TITLE TO ELIMINATE SHORTING OF NTRHGC AND NLAU2G ON 200 TPI			PIB NO. DK3035		
PRODUCT LINE:	TAPE DISK FORMATTER	EQUIPMENT CHANGED Logic PCBA 103685	MODEL SERIES AFFECTED D3000	EFFECTIVE DATE 5/16/75	
CLASS OF BULLETIN:		ORDER PART KIT NO.:	EFFECTIVITY		
<input type="checkbox"/> IMPROVEMENT <input type="checkbox"/> RETROFIT ON FAILURE <input checked="" type="checkbox"/> RETROFIT RECOMMENDED <input type="checkbox"/> SERVICE INFORMATION ONLY		N/A	All OPT46 200 TPI Disk Drives prior to S/N 151600202 with part number 901581, 901587, 901588, 901590 & 901597.		
PURPOSE: There is a possibility that some D3000, 200 TPI, DIABLO OPT46 compatible disk drives were shipped with the internal temperature go line and attention line # 2 shorted together. All drives listed in the effectivity block should be checked for this condition. The attached wire list provides the necessary circuitry to make these signals available at the I/O interface.

TITLE TO ELIMINATE SHORTING OF NTRHGC AND NLAU2G ON 200 TPI	PIB NO. DK3035
---	-------------------

Drawing 103684, Sheet 3, Zone G/11

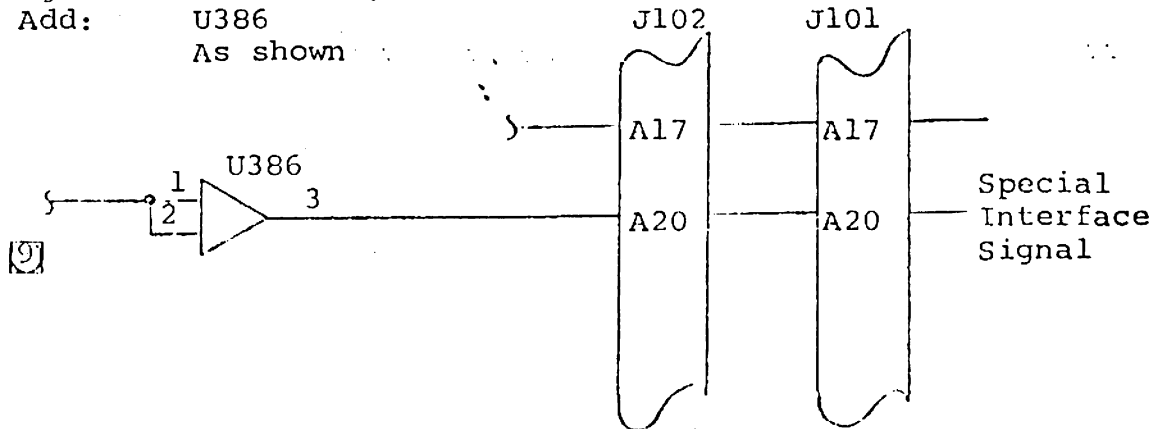
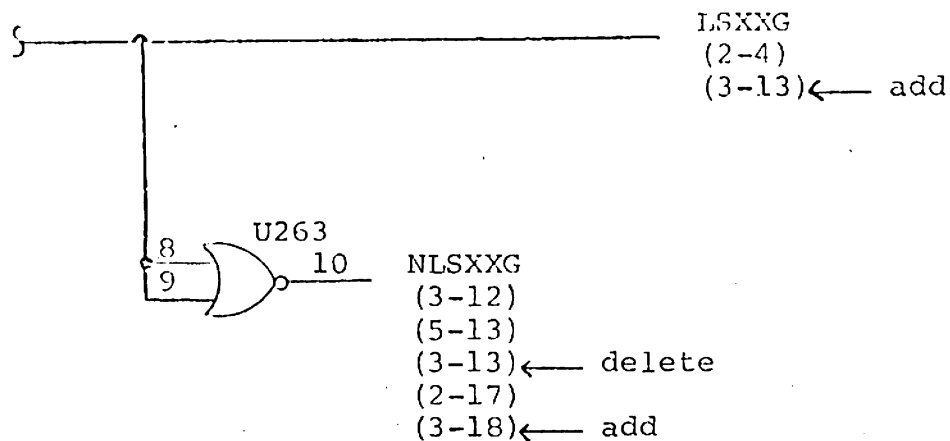
Add: U386
As shown

Zone 18/D (correction of previous dwg error only)

103684, Sheet 3, Zone B/18, 19

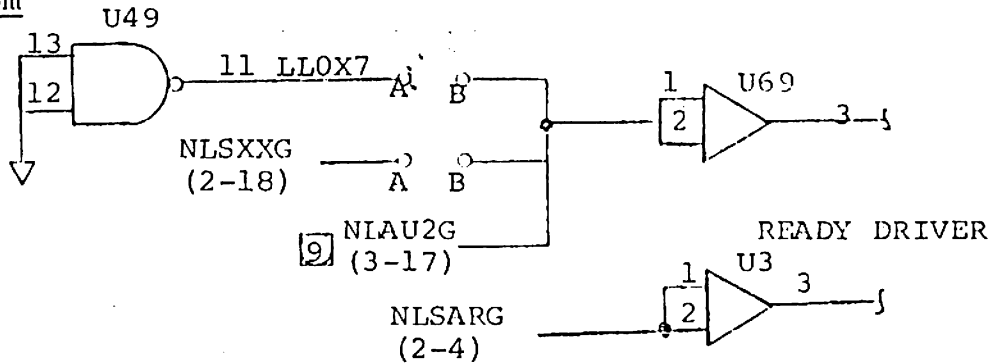
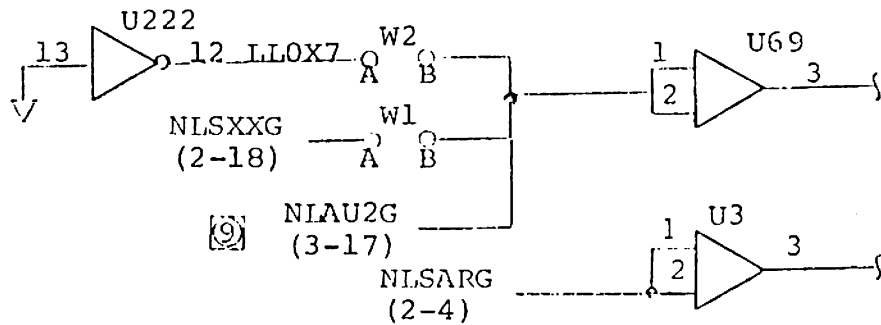
From

To

103684, Sheet 4, Zone C/6, 7, 8

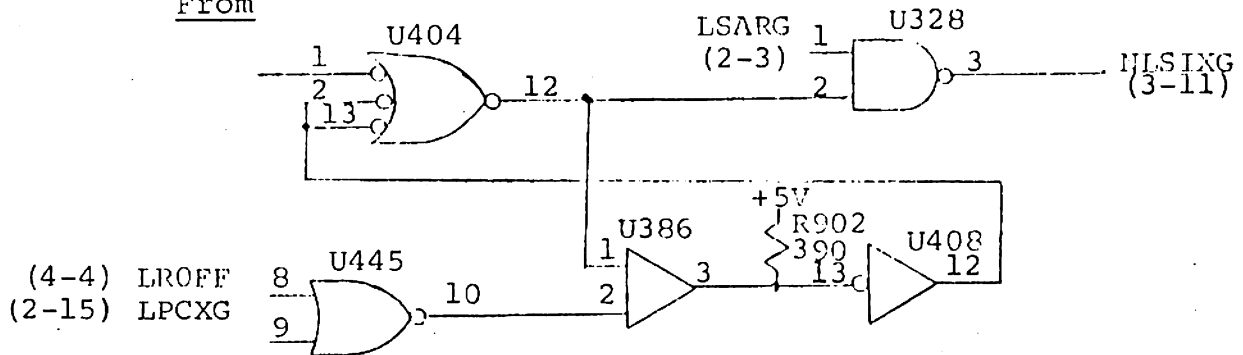
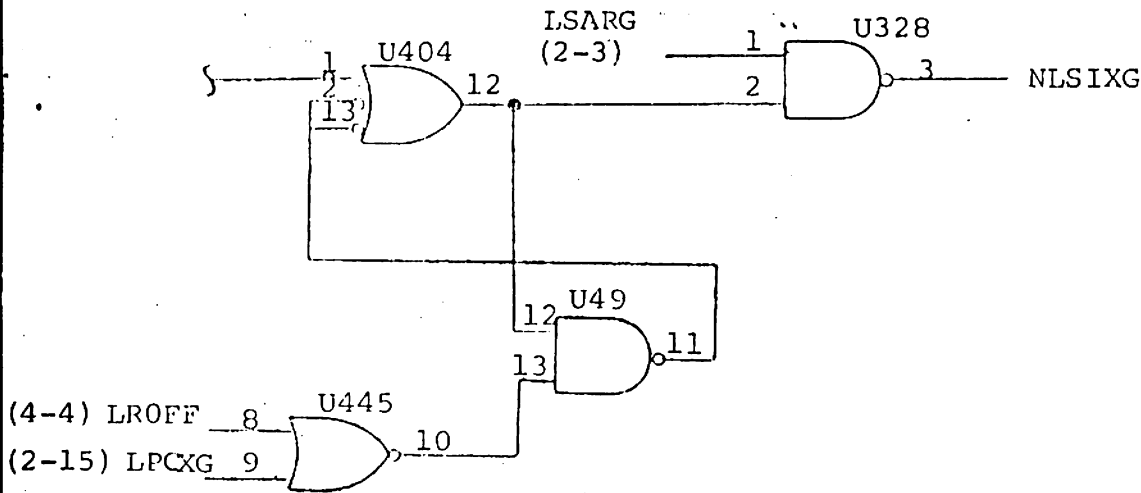
From

To
